MARK	DATE	DESCRIPTIONS	BY	CH'D	CCO#
2	01/31/07	CORROSION PROTECTION	JD	AS	16
1	07/21/06	W2 CAP BEAM ISD	JD	NV	23

SAN FRANCISCO OAKLAND BAY BRIDGE
EAST SPAN SEISMIC SAFETY PROJECT
SELF-ANCHORED SUSPENSION BRIDGE
(SUPERSTRUCTURE & TOWER)

W2 CAP BEAM POST-TENSIONING DETAILS NO. 1

FILE -> I:\bb\04-012001\sas\contract plans and cco\cco\in progress\cco#16\aecpt01.dgn

△1 **PLAN-TENDON TYPE 9**

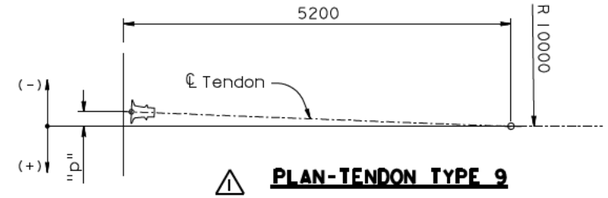
MARK	DATE	DESCRIPTIONS	BY	CH'D	CCO#
△2	01/31/07	CORROSION PROTECTION	JD	AS	16
△1	07/21/06	W2 CAP BEAM ISD	JD	NV	23

⚠1 **ELEVATION** (Cap beam transverse PT tendons)
1:50

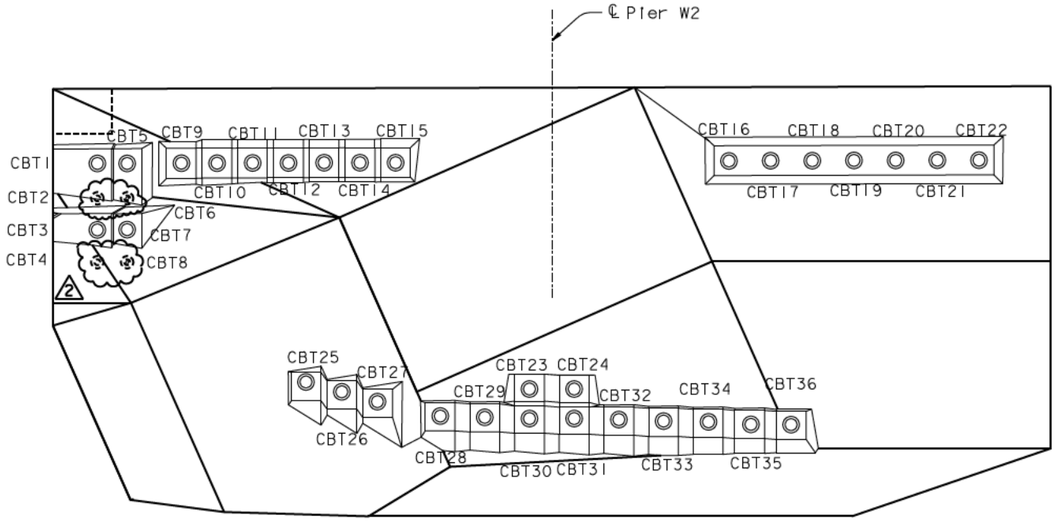
MARK	DATE	DESCRIPTIONS	BY	CH'D	CCO#
2	01/31/07	CORROSION PROTECTION	JD	AS	16
1	07/21/06	W2 CAP BEAM ISD	JD	NV	23
